RFI

RFI #: 217
Date: 1/3/2013
Job: EB-02 Keller Springs Lofts
Phone: 877-777-5115

Subject: Details needed for concrete pole base

SHEET
 2C OF 9

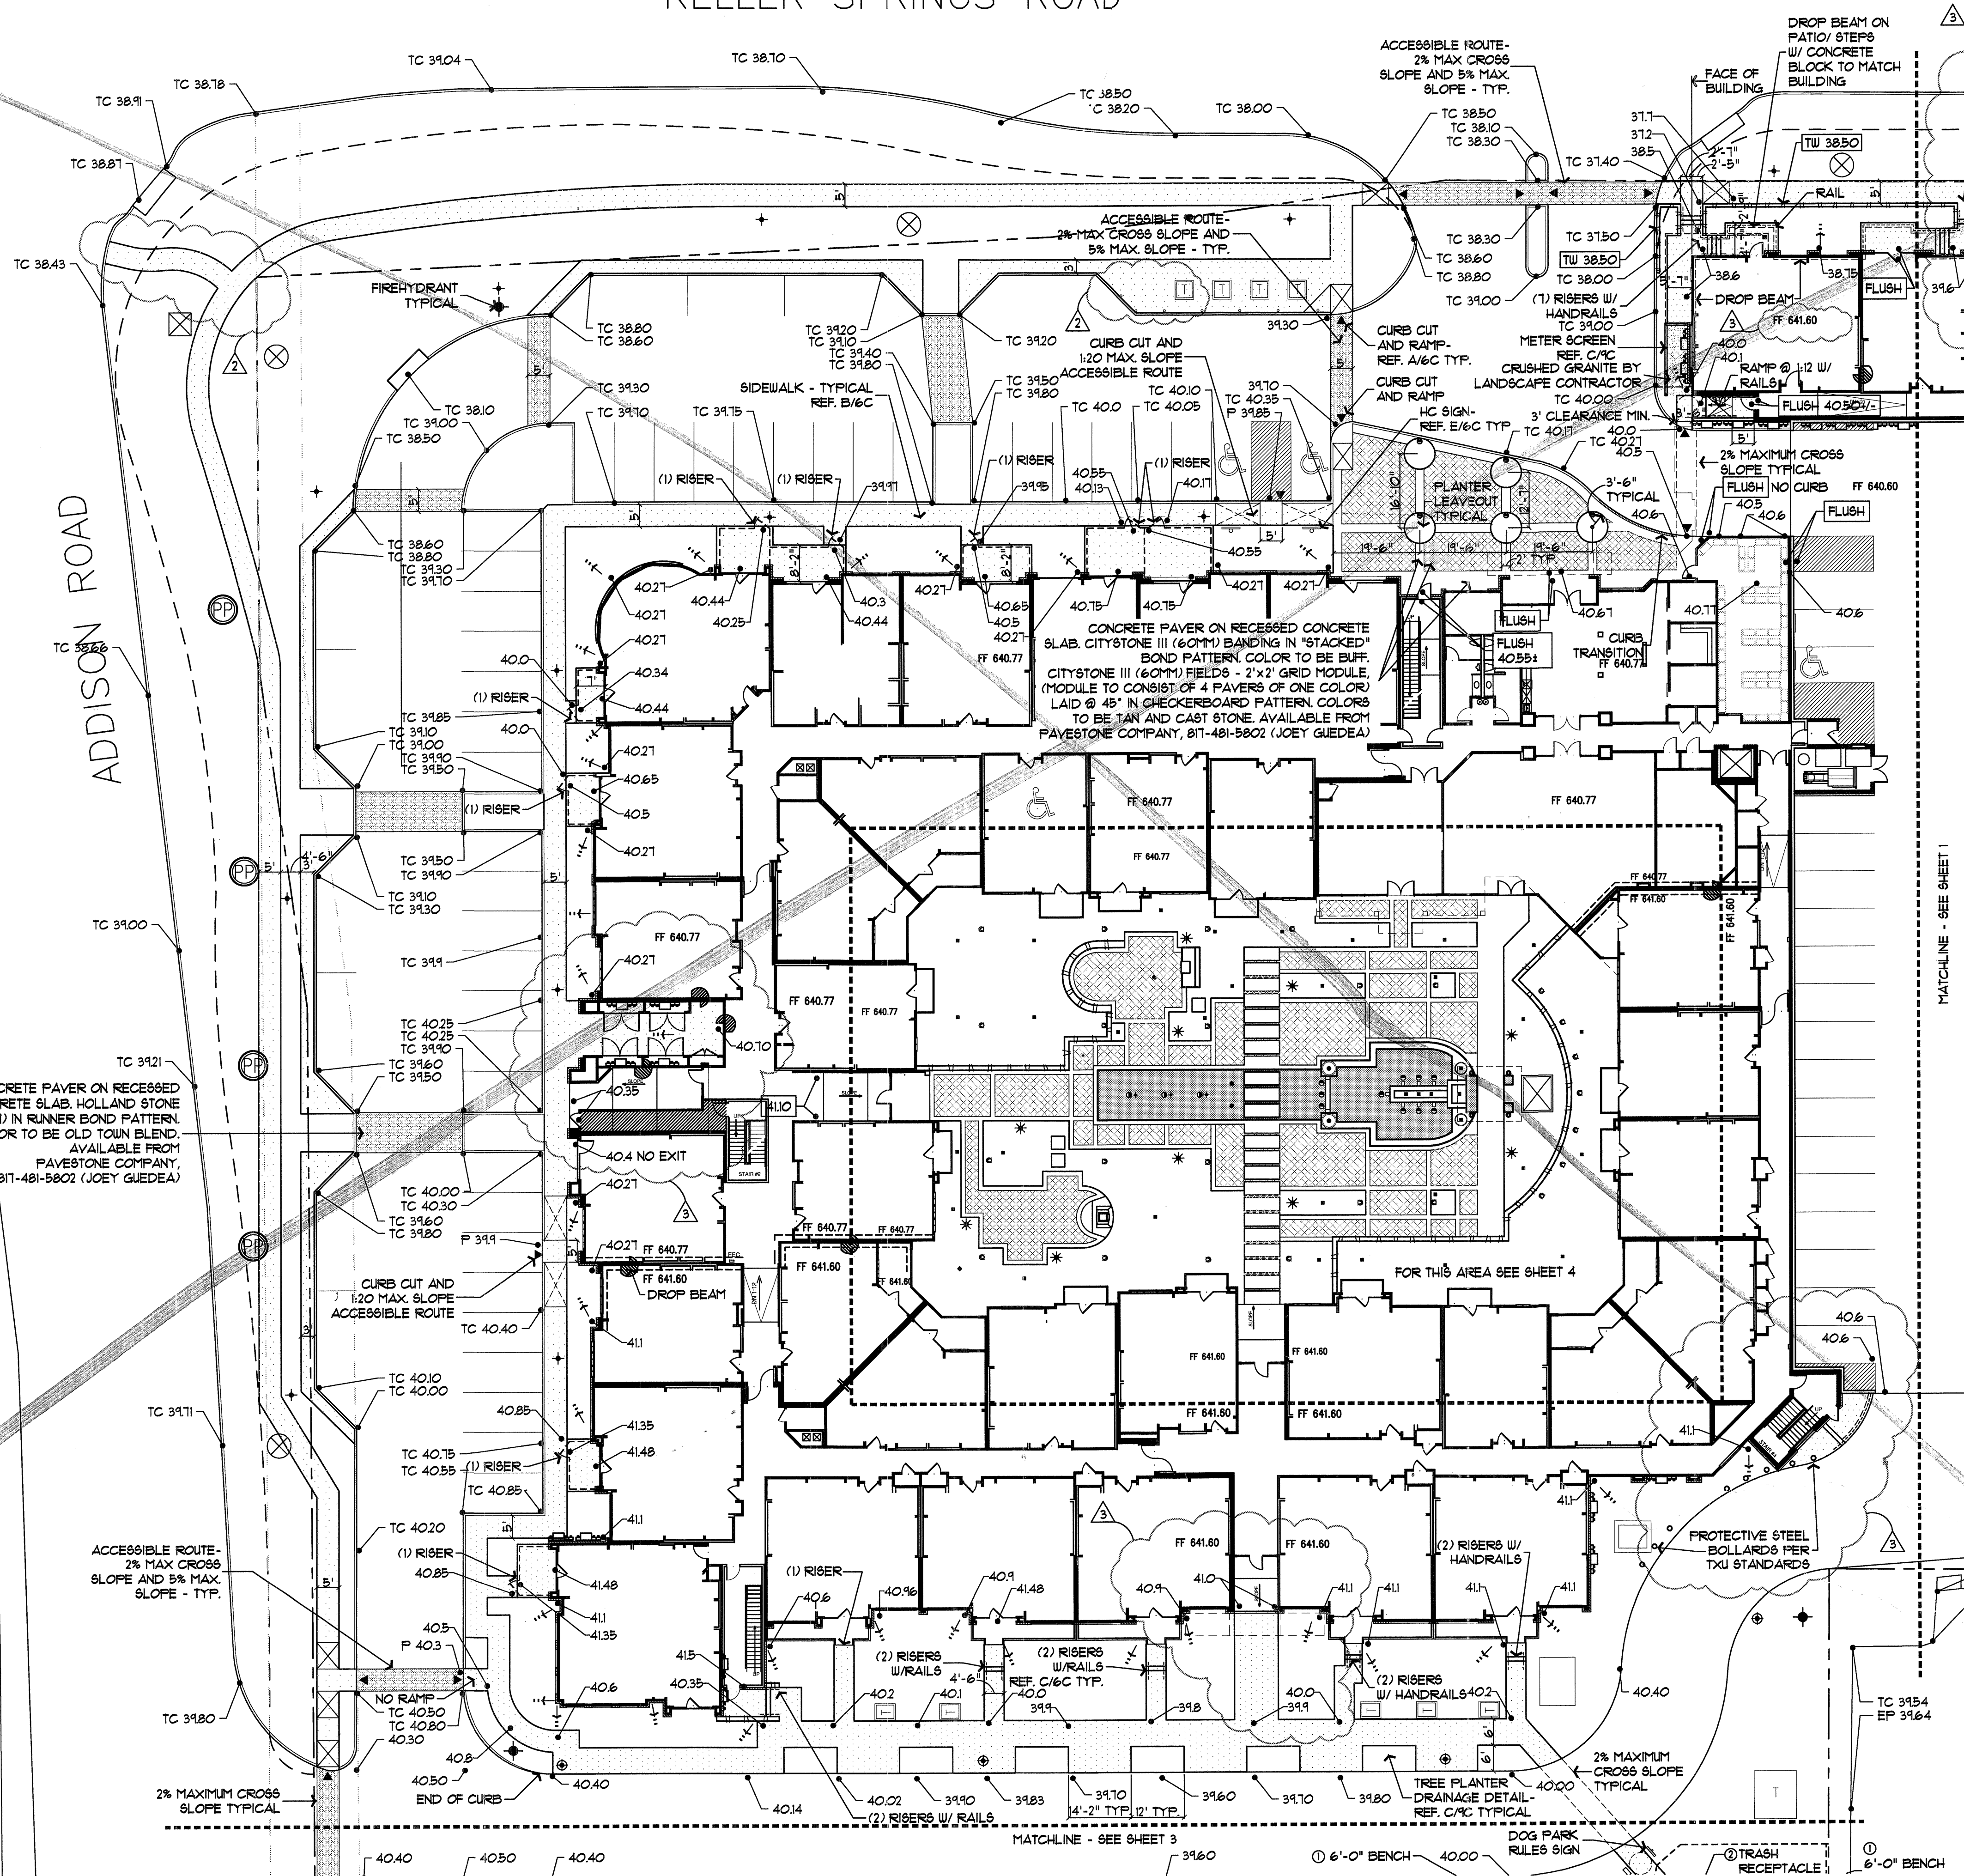
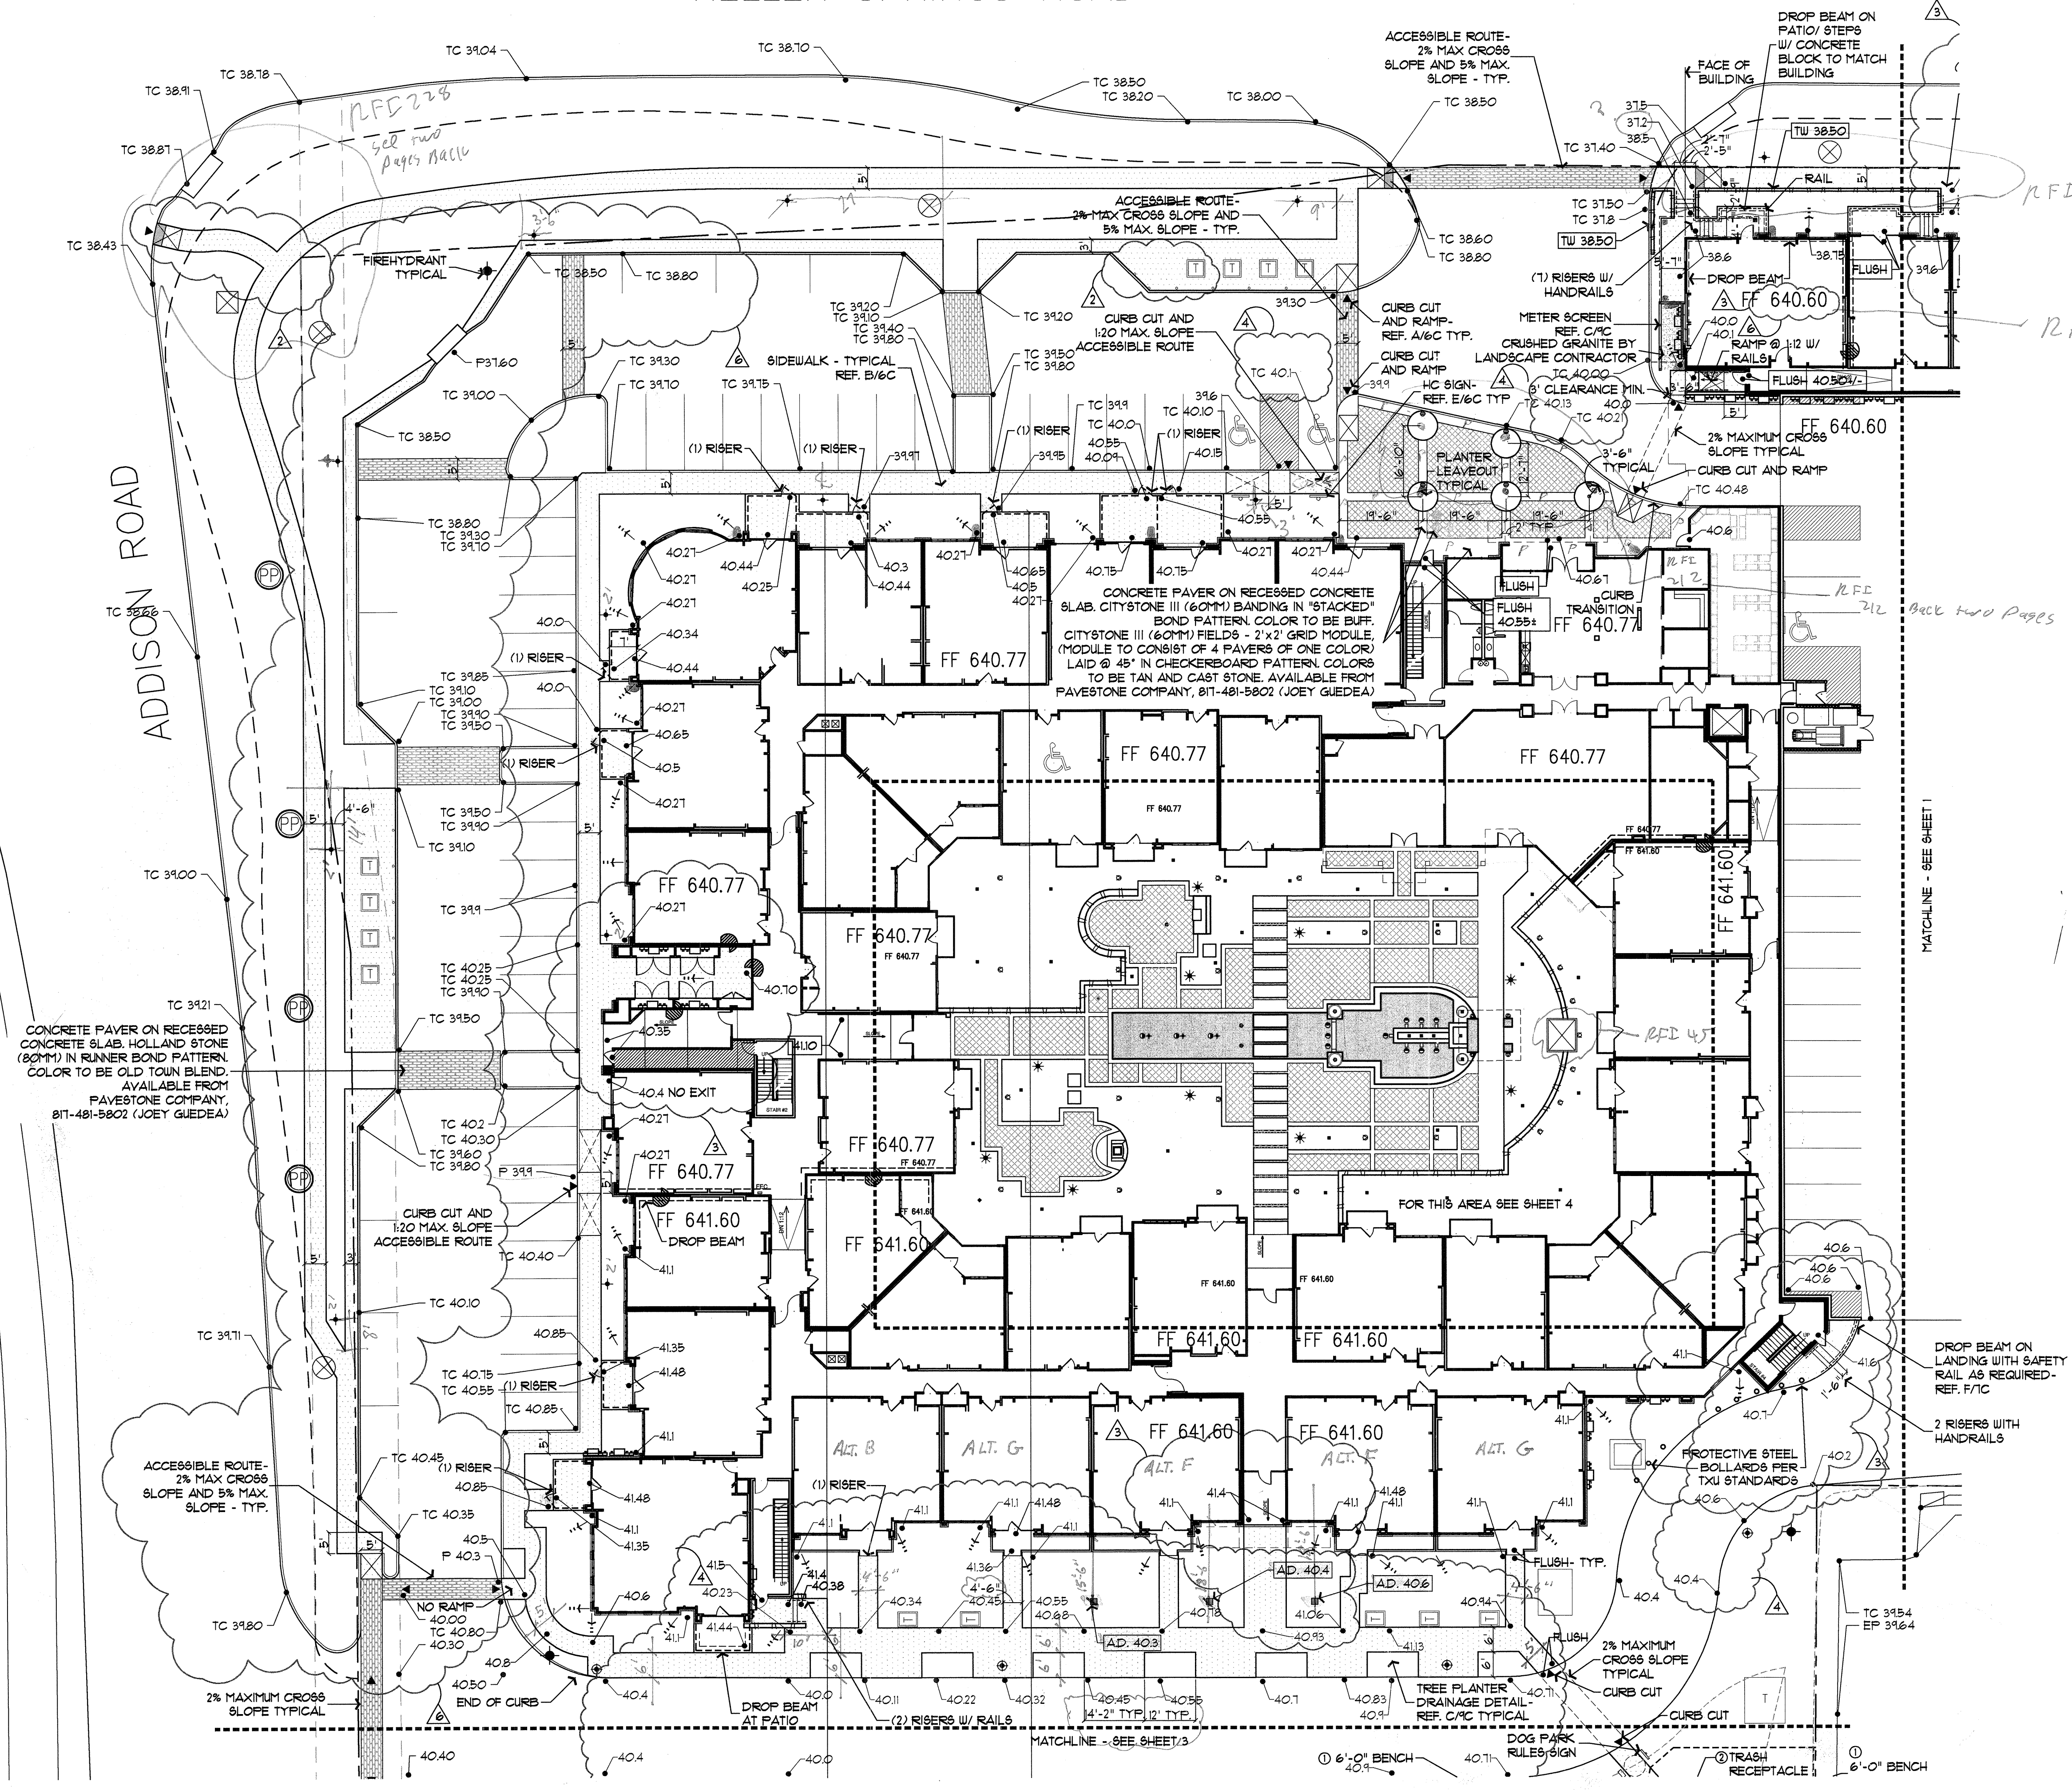
Request: Date Required: 10/26/2012
 On the attached blow-up detail from sheet 2C there are several elevation problems. At the point where the City sidewalk meets the sidewalk from the B2 Part 4 unit there is a low spot elevation that doesn't seem to work. Also the steps from the patio for that same unit do not seem to work. Please review the attachment with comments and provide further direction.

Response:
 I do not understand the issue. Isn't there a curb cut where the sidewalk hits the entry drive? a curb opening puts the drive elevation at 37.00+ - our 37.20 sidewalk point drains at 2% back to the drive and requires three (5' +) risers
